EUREKA DFM

Design for Manufacturability Analysis

Part ID: Unknown
Date: 2026-06-14 01:08

Face: 2 · Plane · 8.0 mm²

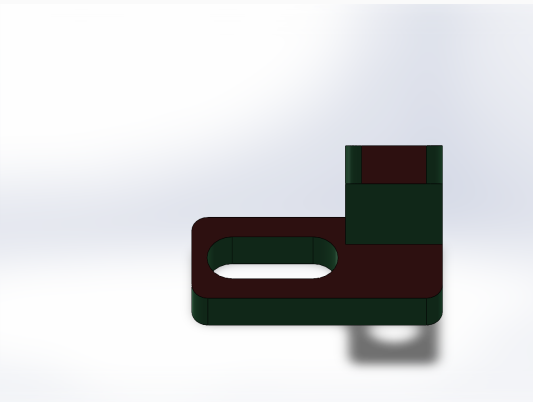
[Severity.CRITICAL] INJ-UNDERCUT-001

Description: Face 2 is undercut -- normal opposes pull direction by 135.0deg. Requires side-action or redesign.

Measured: 135.0deg from pull
Required: <=90deg (no undercut)

Fix: Redesign face to align within 90deg of pull direction, or add a side-action/lifter to the mould tool.

Face: 11 · Plane · 57.3 mm²

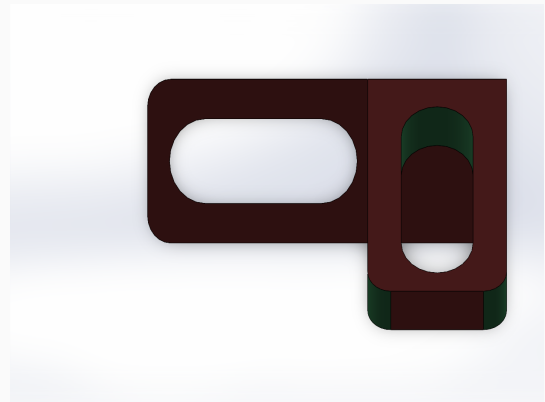
[Severity.CRITICAL] INJ-UNDERCUT-001

Description: Face 11 is undercut -- normal opposes pull direction by 180.0deg. Requires side-action or redesign.

Measured: 180.0deg from pull

Required: <=90deg (no undercut)

Fix: Redesign face to align within 90deg of pull direction, or add a side-action/lifter to the mould tool.

Face: 15 · Plane · 40.8 mm²

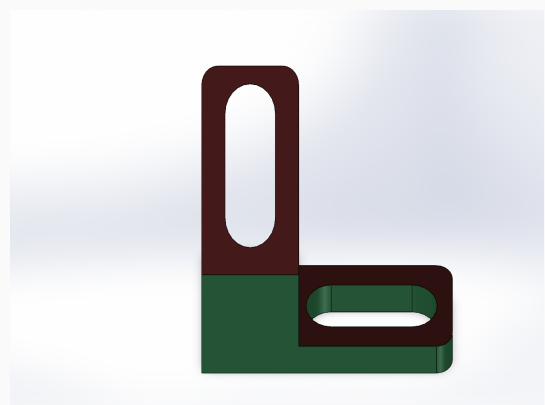
[Severity.CRITICAL] INJ-UNDERCUT-001

Description: Face 15 is undercut -- normal opposes pull direction by 135.0deg. Requires side-action or redesign.

Measured: 135.0deg from pull

Required: <=90deg (no undercut)

Fix: Redesign face to align within 90deg of pull direction, or add a side-action/lifter to the mould tool.
